SERVICE FLASH

DW0905

Dishwasher Door Drops Below 90°

BRAND Electrolux

Figure 1

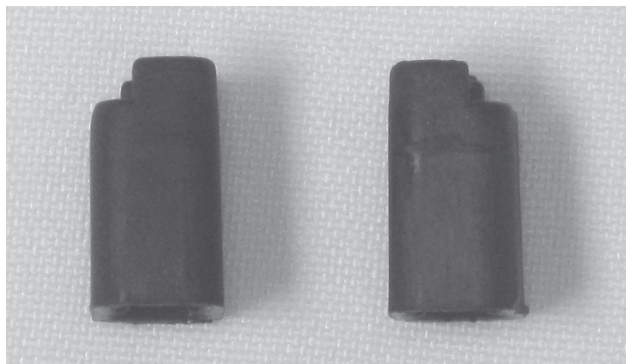
PROBLEM The door, when fully opened, goes down more than 90°. Then as the lower rack is pulled from the tub, the lower rack rolls off the door and onto the floor.

CAUSE The hinge stop has bent in, allowing the door to drop too far down.

SOLUTION The hinge stops on both hinges need to be opened up and a hinge stop wedge installed, this will keep the door at the proper angle. A service kit has been assembled which supplies two wedges, one for each hinge, (See Figure 1) and an instruction sheet which shows how to install the wedges properly. The part number for the kit is 154775901.
